Angela Knight (MS 305)  
East Bay Municipal Utility District  
375 Eleventh Street  
Oakland, CA 94623

August 2, 2001

This letter presents comments on the Draft Environmental Impact Report (DEIR) for the East Bay Municipal Utility District (EBMUD) Bayside Groundwater Project dated March 2001. These comments, many of which were raised during the seven public comments meetings, are listed below:

Figure 3

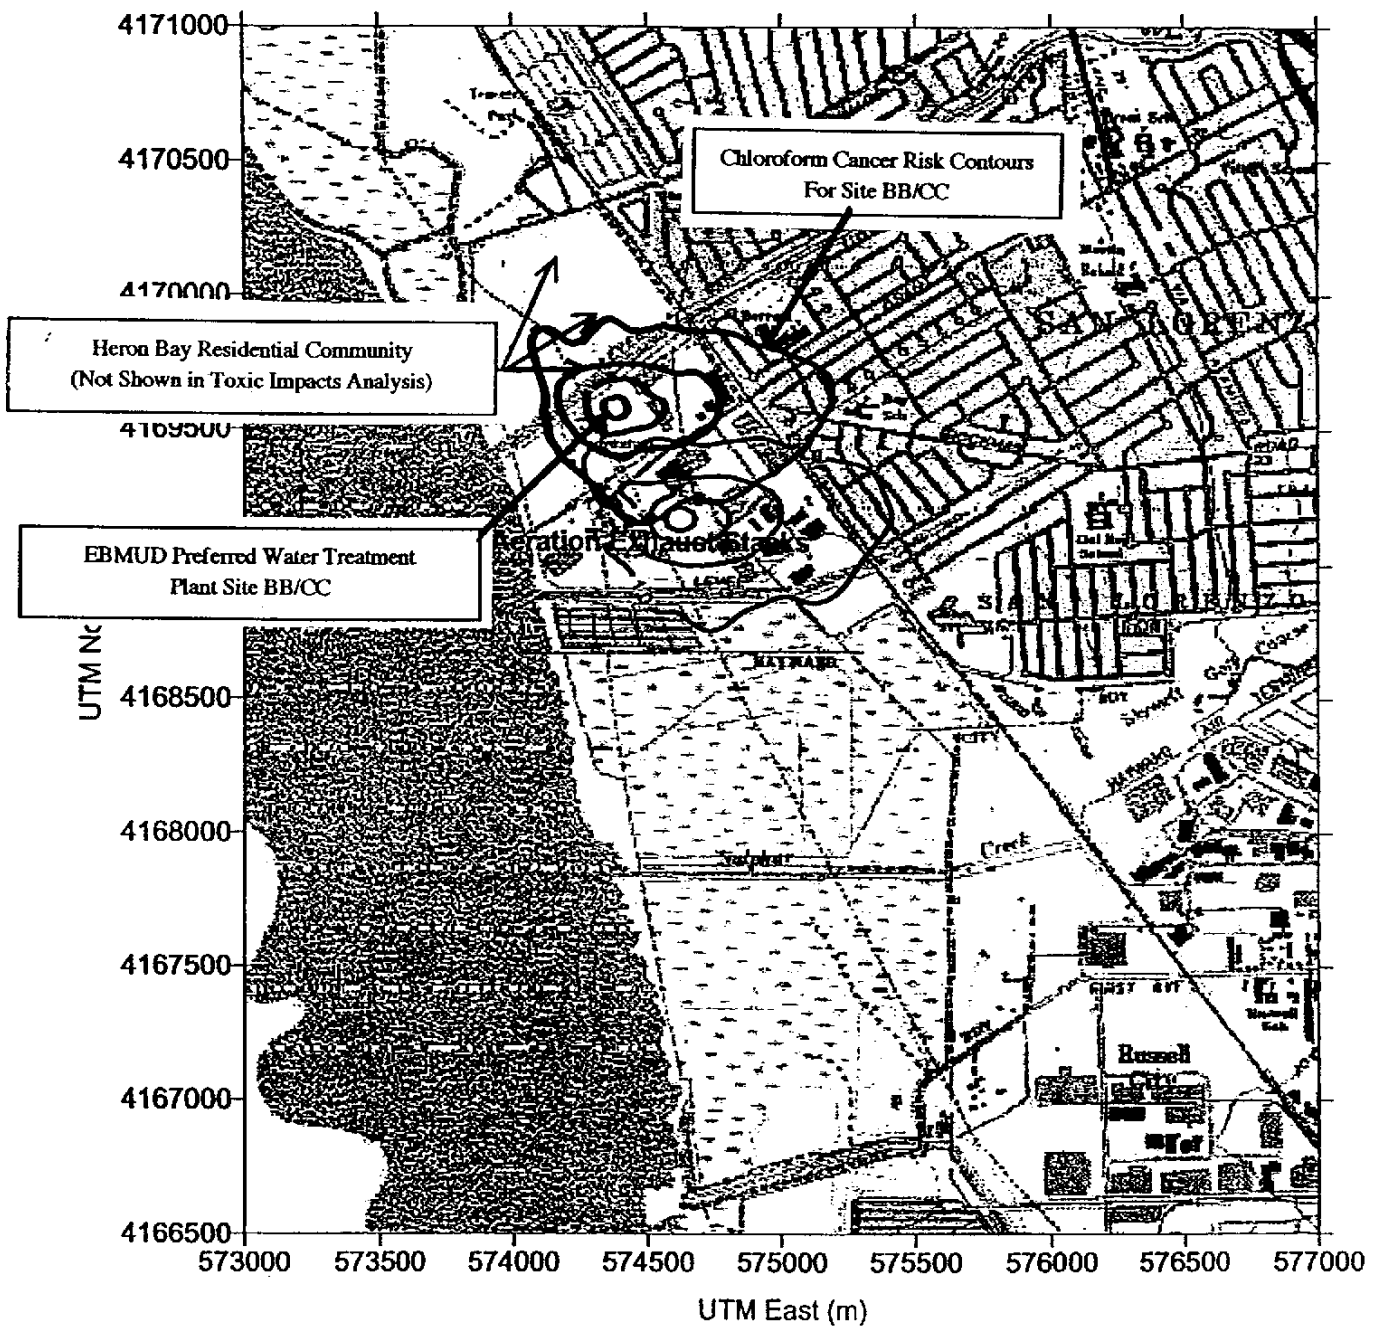
In addition EBMUD did not include results of an air toxics impact analysis for a San Lorenzo Air Stripper in the DEIR. This analysis, made available to the public for viewing on April 20, 2001 at the EBMUD office, included an incremental lifetime cancer risk study and illustrated the chloroform cancer risk contours resulting from operation of the proposed air strippers. This impact analysis, dated March 9, 2001 should have been made available for the entire public to review in the March 23, 2001 DEIR as this information sheds light on the cancer risks to the community. Even more concerning is that this analysis does not reflect the toxic effects of the EBMUD preferred alternative sites closest to residential neighborhoods. To illustrate our concerns, we have sketched the chloroform cancer risk contours in the EBMUD preferred site next to the Heron Bay and San Lorenzo residential communities (see Attachment 2). It is noted that EBMUD did attempt to address this situation by posting the above mentioned March 9th report on its website after May, 1, 2001, but changed the original report (changed pg. 3 from +/- 50% accuracy to 10% accuracy) during the DEIR process.

How is EBMUD allowed to change results from an original air toxics analysis memorandum during the DEIR process, immediately after the public showed outrage during the May 1, 2001 public comment meeting over the recently disclosed air toxics analysis? How can there be two of the same documents presenting different information floating around during a public comment period? Please see Attachment 3 (pg. 3 of the 3/19/01 memo with a +/- 50% accuracy made available for public viewing at EBMUD offices) and Attachment 4 (pg. 3 of the 3/19/01 memo with a +/- 10% accuracy made available for public viewing on the internet).
